APPLICATION NO.	FILING DATE	FIRST NAMED INVENTOR	ATTORNEY DOCKET NO.	CONFIRMATION NO.
10/705,386	11/10/2003	Pierre Liu	. 2011137	4320
75	90 07/12/2006		EXAMINER	
Keith Kline PRO-TECHTOR INTERNATIONAL 20775 Norada Court Saratoga, CA 95070-3018			TRAN, THIEN F	
			ART UNIT	PAPER NUMBER
			2811

DETAILED ACTION

FIG. 5E

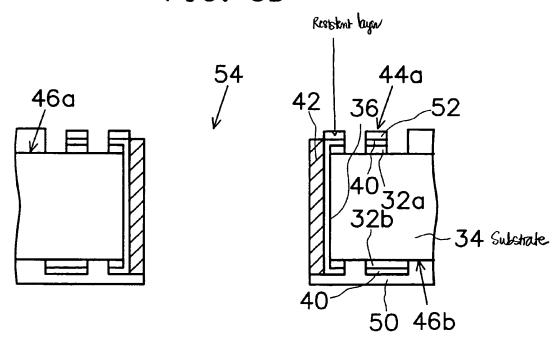
forming with a plurality of connected points (44a), the length of the wiring regions are smaller than long slot (54) of the substrate (34); a layer (52 shown in Figs. 5E) is characterizes as a resistant layer (see attached Figs. 5E, 7) coated on the lower surface of the substrate (34), and located between the long slot (54) and wiring region; a glue layer 58 being coated on the upper surface of the substrate and being located at the periphery of the long slot (54); an integrated circuit (56) having a first surface (64) forming with a plurality of bonding pads (60) and a second surface, the first surface (64) being adhered to the glue layer (58), then the bonding pads (60) being exposed from the long slot (54) of the substrate (34); a plurality of wires (62), each of which is arranged within the long slot (54) of the substrate and is electrically connected the bonding pad (60) of the integrated circuit (56) to the connected point (44a) of the substrate; and a first compound layer (68) being filled within the long slot (54) of the substrate for protecting the each wire.

resistant layer coated on the lower surface of the substrate between the long slot and wires region, the examiner respectfully disagrees with the remark. It is clear that Chang teaches a resistant layer (52) coated on the lower surface of the substrate (34) and between the long slot (54) and wiring regions.

FIG. 7

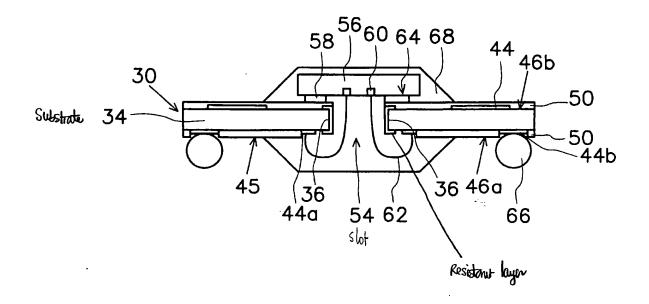
Chang discloses an integrated circuit package (Figs. 4, 6-7) having central leads comprising: a substrate (34) having an upper surface, a lower surface, and a long slot (54) penetrating from the upper surface to the lower surface, the lower surface forming with wiring regions arranged at the two sides of the long slot (54), and the wiring regions
